Access Compliance Report

Public Rights-of-Way

(Curb Ramps)

Intersection ID: 52692	Main Street: ARBOR_LOOP_DR	Cross Street: ANSLEY_GARDEN_DR	Location: S
ADA ID: 0612EB3C579E	Ramp Type: Directional1	Initial Pass/Fail: Fail	Overall Compliance: No
		Severity Score: 1.25

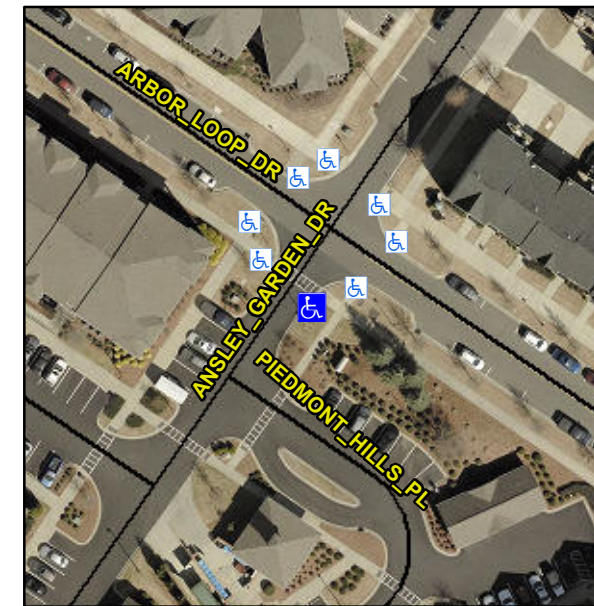
Compliance	Description	Data	Compliance	Description	Data
N/A	Ramp Length (in)	76.0	N/A	Grade Break?	N/A
Yes	Ramp Width (in)	70.0	N/A	Grade Break Slope (%)	0.0
Yes	Ramp Slope (%)	5.4	N/A	Grade Break XSlope (%)	0.0
No	Ramp XSlope (%)	3.0			
N/A	Flare Type LT	N/A	N/A	Flare Type RT	N/A
N/A	Flare Slope LT (%)	N/A	N/A	Flare Slope RT (%)	0.0
N/A	Flare Traversable LT?	N/A	N/A	Flare Traversable RT?	N/A
N/A	Landing Length (in)	0.0	N/A	DWS Provided?	N/A
N/A	Landing Width (in)	0.0	N/A	DWS Contrast?	N/A
N/A	Landing Slope (%)	0.0	N/A	DWS Length (in)	N/A
N/A	Landing X Slope (%)	0.0	N/A	DWS Full Width?	N/A
N/A	Landing Curb? (Y/N)	N/A	N/A	DWS Offset LT (in)	N/A
N/A	Shared Landing?	N/A	N/A	DWS Offset RT (in)	N/A
N/A	Gutter Ponding?	0.0	N/A	Gutter Slope (%)	N/A
N/A	Gutter Lip Ht (in)	0.0	N/A	Gutter X Slope (%)	N/A
N/A	Painted X Walk1?	Yes		Road Slope (%)	0.2
	X Walk 1 Direction	To NW		Road X Slope (%)	1.7
	X Walk 1 Width (in)	66.5		Clear Space?	N/A

X Walk 1 Slope (%)	0.2	N/A	Clear Space to XWalk (in)	N/A
	X Walk 1 X Slope (%)	1.7	N/A	Storm Grate/Utility Hazard?	N/A
N/A	Ramp inside XWalk1?	Yes		Storm Grate/Utility Type	
N/A	Any Obstructions?	N/A			N/A
	Obstruction Type		Yes	Surface Condition? (G/P)	Good
			N/A	Curb Slope (%)	8.7

Remove & Replace Entire Ramp.
